SUBSURFACE WASTEWATER DISPOSAL SYSTEM APPLICATION

S095-045

Town Or Plantation	Augusta
Street Subdivision Lot #	574 Church Hill Rd

Revised 6/14/95 To Change The Texture of The Fill Materials and Add Certain Drain IDA

INFILTRATOR CROSS SECTION

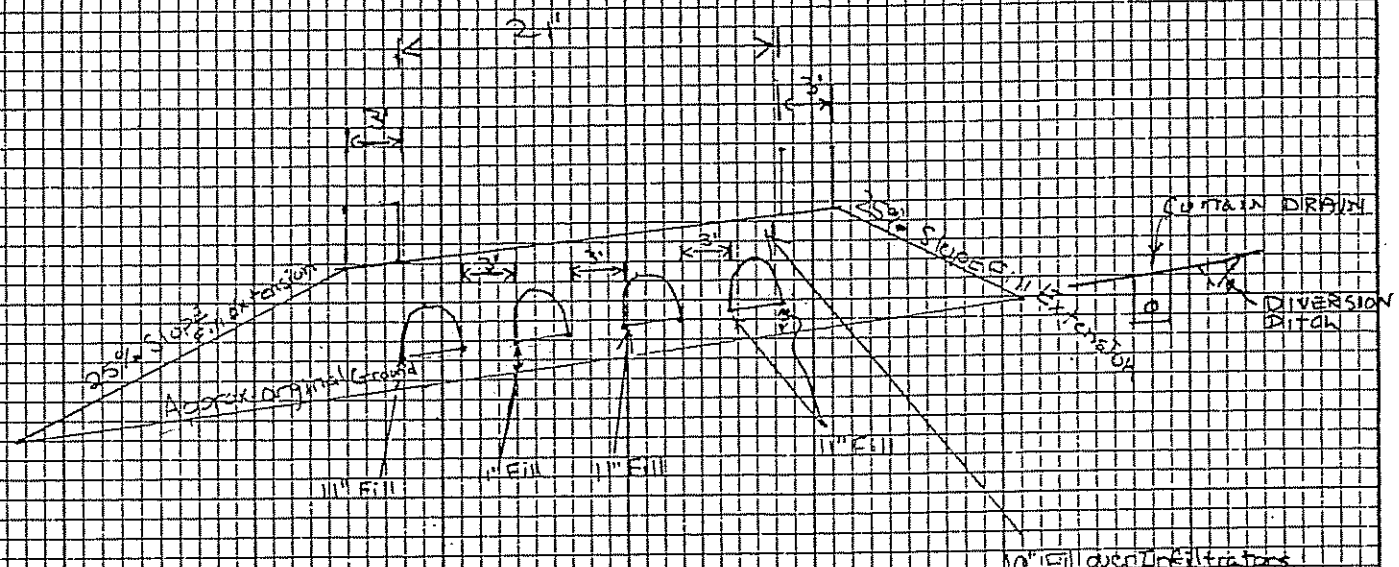
FILL UNDER INFILTRATORS TO BE ~~Sand Loam~~ TEXTURE.

FILL AROUND INFILTRATORS TO BE ~~Sandy Loam~~ TEXTURE Coarse Loamy Sand TDA 6/14/95

ORIGINAL GRADE Coarse Loamy Sand TDA 6/14/95
